SZS ENGINEERING ACCESS

ELECTION DIVISION

ILA COMPLIANCE REPORT (21 MONTH)

2426 TH STREET, EUREKA CA
(COUNTY LEASED FACILITY)

Field Date: 10/29/2019 Report Date: 10/29/2019 Barrier #: 25B

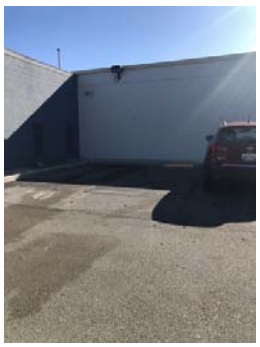
Barrier Description: No reflectorized ISA sign posted at front of stall

Code References: CBC 11B-502.6 and 2010 ADAS 502.6

As Built Description: Accessible stall at furthest point from facility entrance removed from use

Proposed Solution: Barrier removed

Field Date: 10/29/2019 Report Date: 10/29/2019 Barrier #: 25F

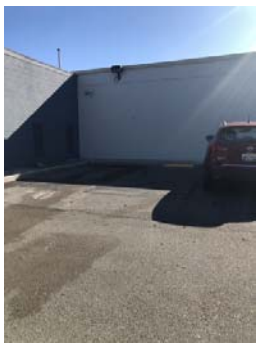
Barrier Description: Access aisle provided does not extend the full length of the stall

Code References: CBC 11B-502.3.2 and 2010 ADAS 502.3.2

As Built Description: Accessible stall at furthest point from facility entrance removed from use

Proposed Solution: Barrier removed
